APPLICATION FOR PERMISSION
UNDER SECTION 16 OF
THE TOWN PLANNING ORDINANCE
(CAP. 131)

For Official Use Only 請勿填寫此欄	Application No. 申請編號	A/NE-KS/553
	Date Received 收到日期	11 FEB 2025

- 1.1 The applicant seeks planning permission from the Town Planning Board (the Board) to use *Lots 2219 (Part) and 2220 (Part) in D.D. 92, Kwu Tung South, Sheung Shui, New Territories (the Site)* for **'Proposed Temporary Warehouse (Excluding Dangerous Goods Godown (D.G.G.)) with Ancillary Facilities for a Period of 3 Years'** (proposed development) (**Plan 1**).
- 1.2 The applicant, a construction and engineering company, intends to use the Site to continue operating the warehouse for the storage of the company's construction materials in order to support the growing demand in the construction industry and the development of various New Development Areas across the New Territories.

SCALE 1 : 1000 @ A4	
DRAWN BY MN	DATE 17.1.2025
CHECKED BY	DATE
APPROVED BY	DATE
DWG. TITLE LAYOUT PLAN	
DWG NO. PLAN 4	VER. 001

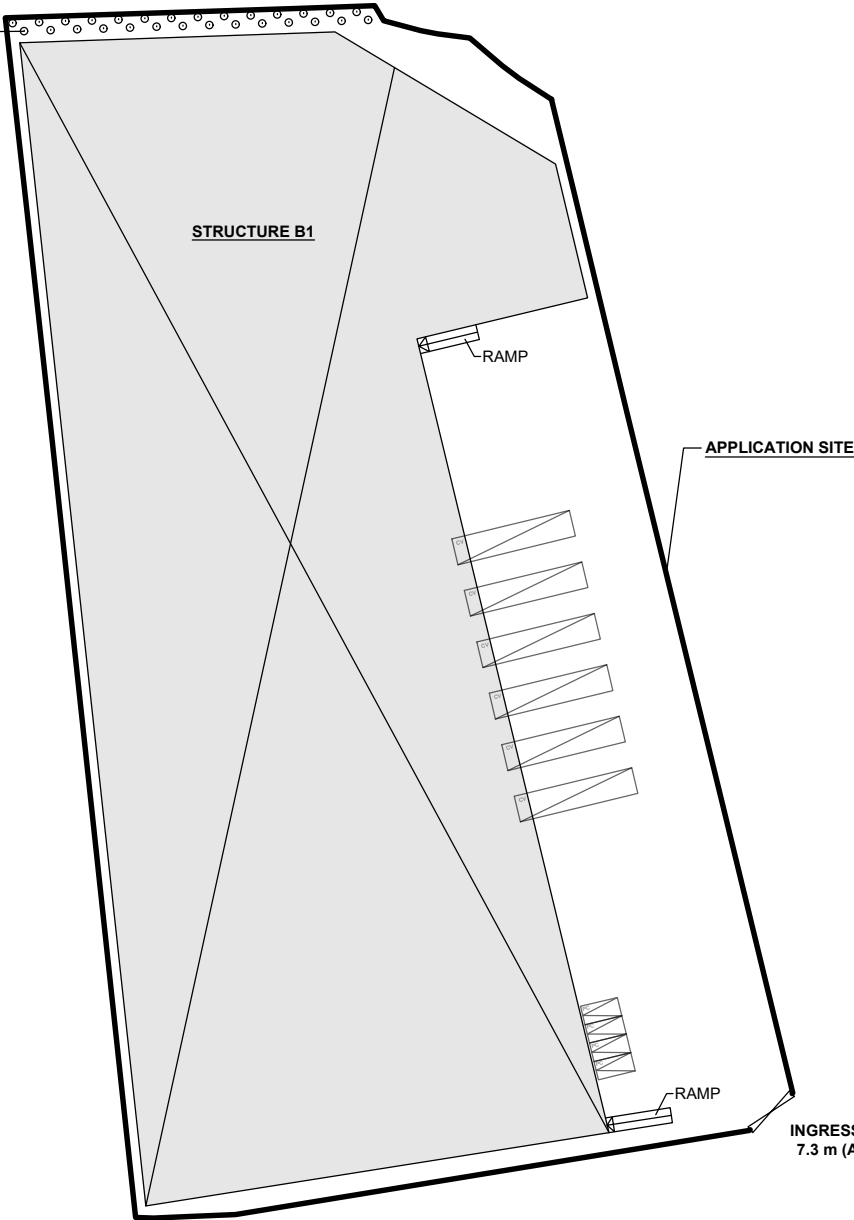
(c)	<p>The applicant proposed to plant 28 number of trees along the northern boundary of the Site as shown on the Layout Plan (PLAN 4.ver.001). The species and size of proposed trees, the dimension of planting area and soil depth for tree planting should be provided to ensure</p>

FIRE SERVICES NOTES:

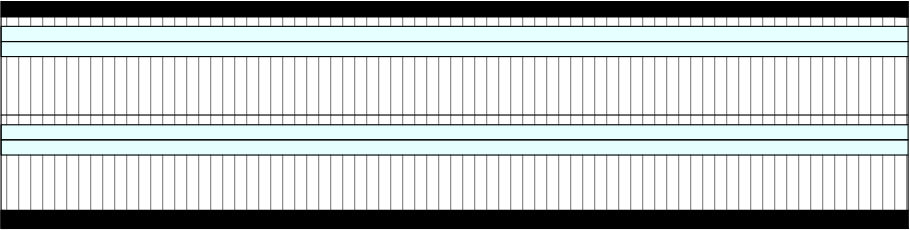
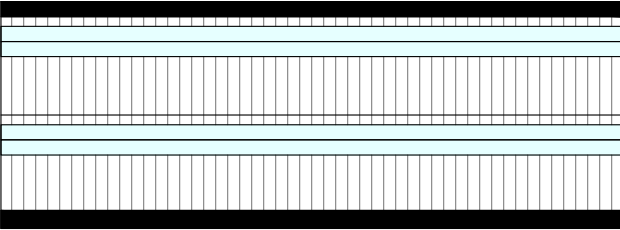
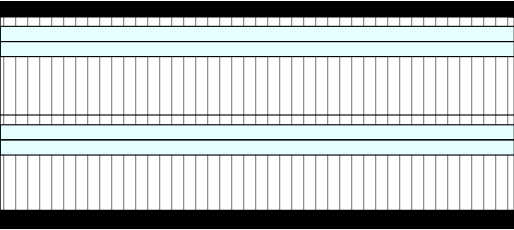
2. Comments of the Director of Fire Services (D of FS) (Contact Person: Mr. LI Chi-fung; Tel.: 2733 5844)		
(a)	The sprinkler control valve group shall be clearly marked on plans;	Noted. The applicant will submit a revised fire service installations (FSIs) proposal for the consideration of the D of FS to enhance fire safety of the Site after planning approval has been obtained from the Town Planning Board (the Board).

(b)	The minimum clearance around each single storage block (i.e. 2.4 m) & Max. storage block area of 50m shall be specified in the FS Notes;	
(c)	Modified hose reel system shall be provided in accordance with the FSI CoP 2022;

(d)	The alarm bell should be located and incorporated with each hose reel and clearly indicated on plans.	
(e)	The G/F and 1/F of a structure shall be regarded as separate compartments. Therefore, the calculations of openable windows for compartments shall be provided accordingly and precisely indicated on plans.

Annex II
Drainage Proposal

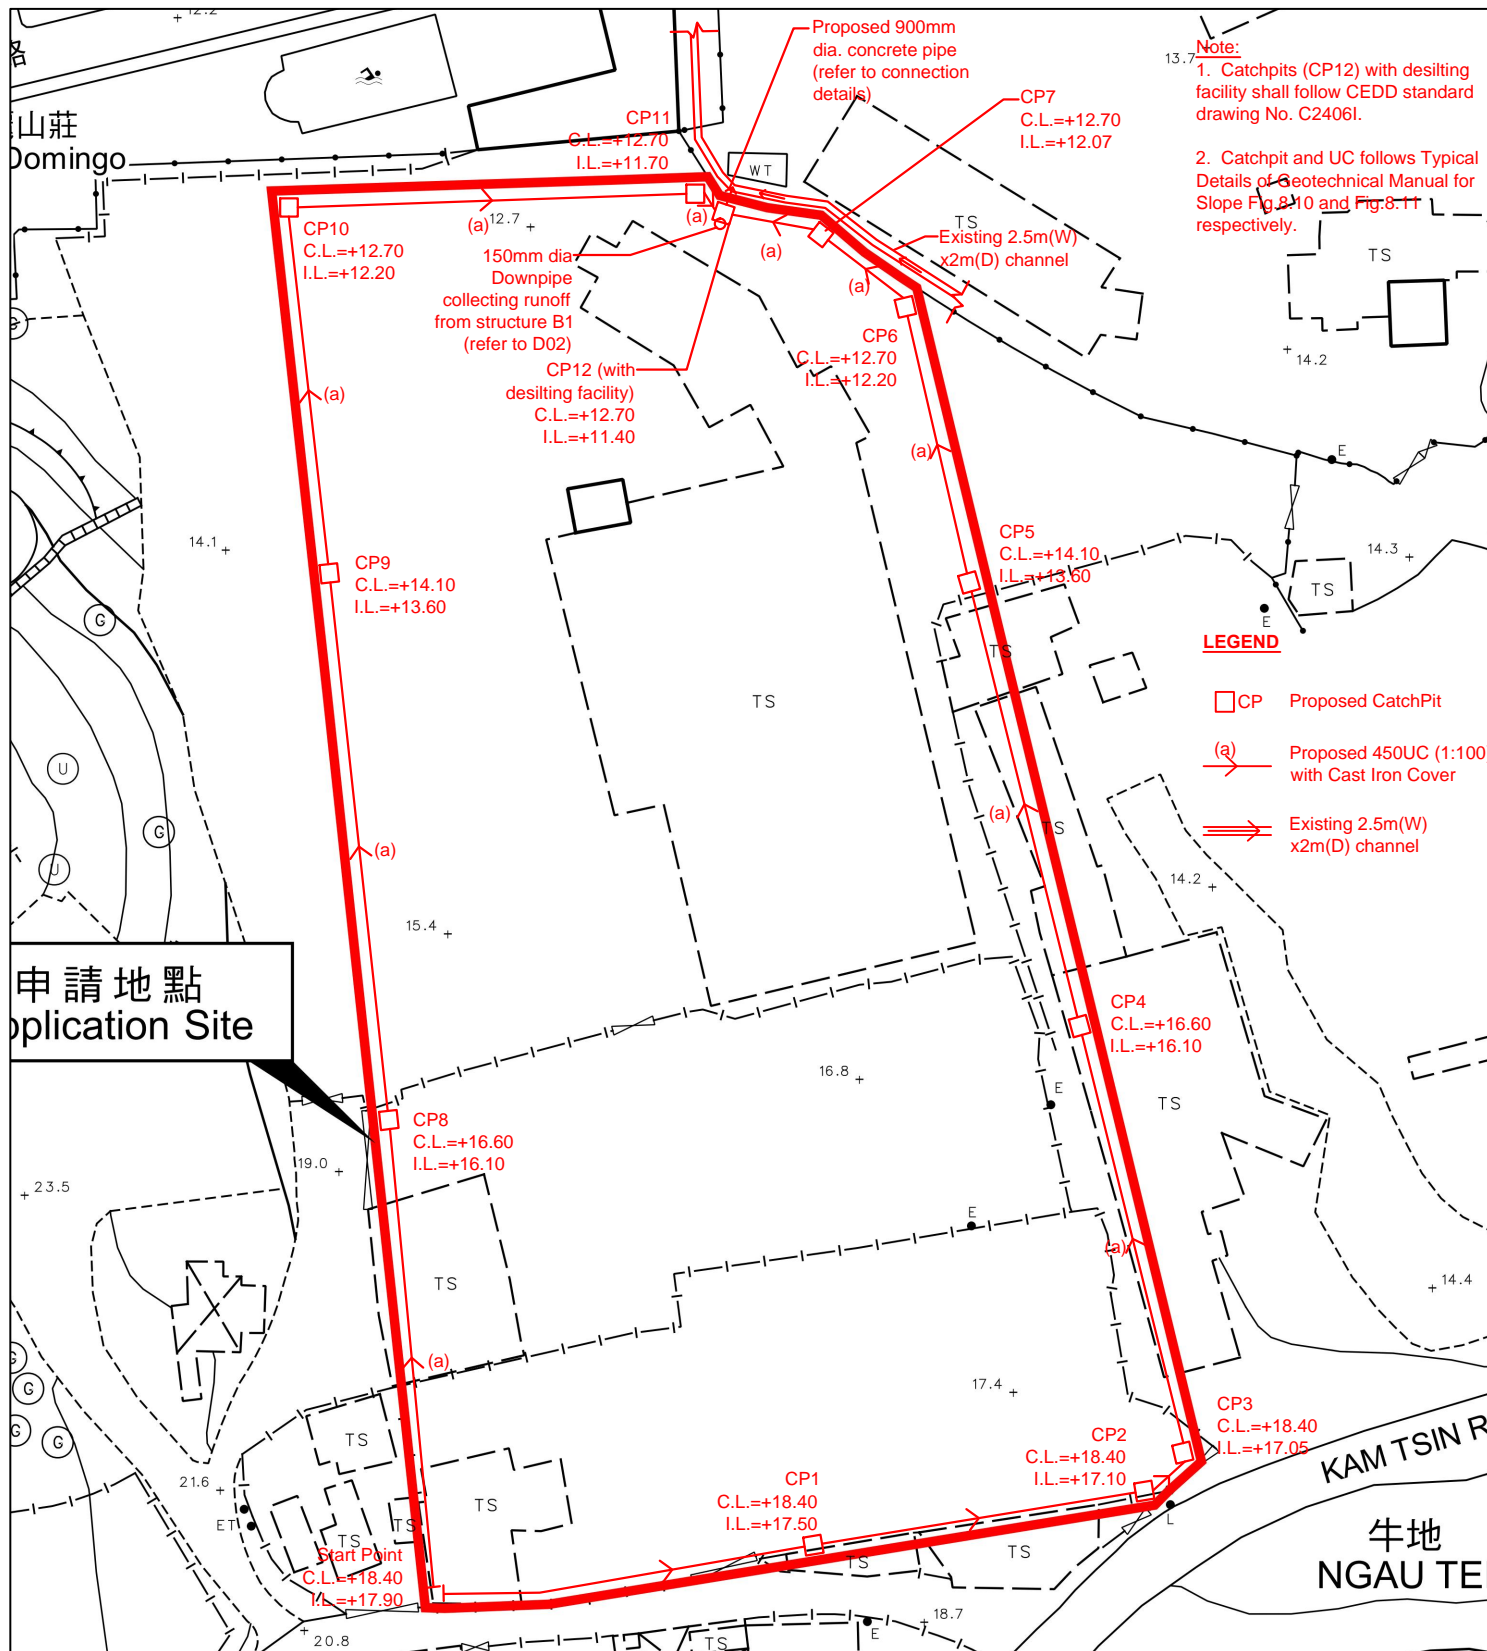
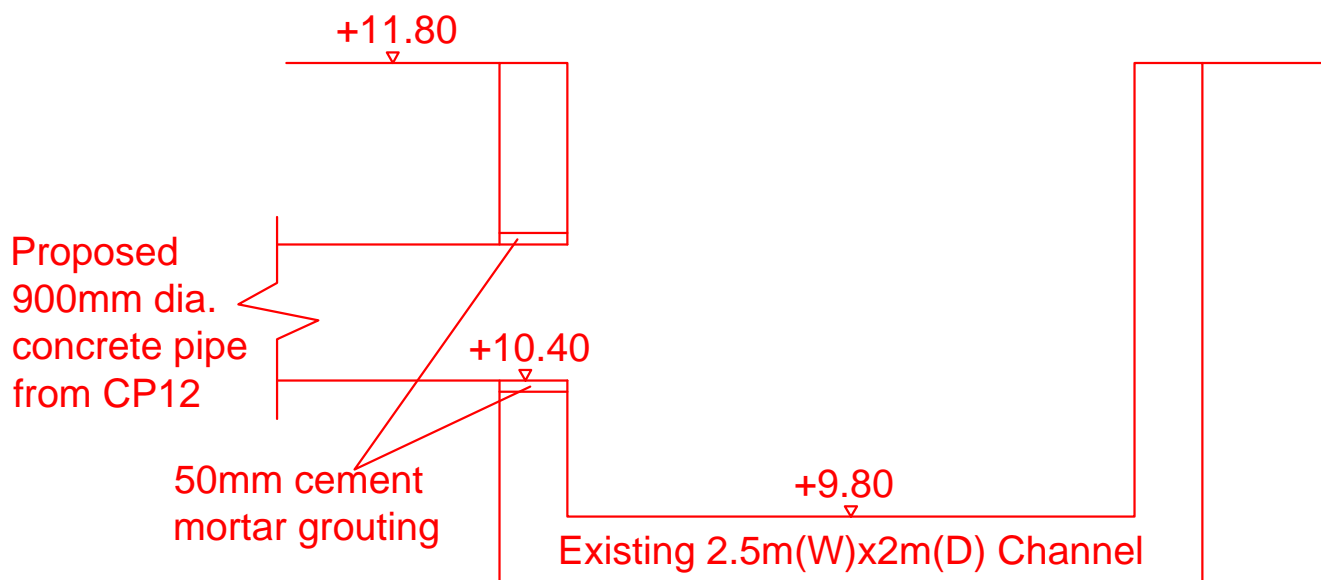
8. Comments of the Chief Engineer/Mainland North, Drainage Services Department (CE/MN, DSD) (Contact Person: Mr. Keith LIU; Tel.: 2300 1595)		
(a)	As the roof layout was changed, the applicant should revise drawing no. KTS517/D02	Noted. A revised drainage proposal is provided by the applicant to review the drainage arrangement (Annex II). During the operation of the proposed development, surface runoff arising from the Site will be collected by the peripheral U-channel and eventually discharged to the existing channel situated to the northeastern of the Site. The calculation shows that the proposed drainage facilities can handle the runoff from the Site.
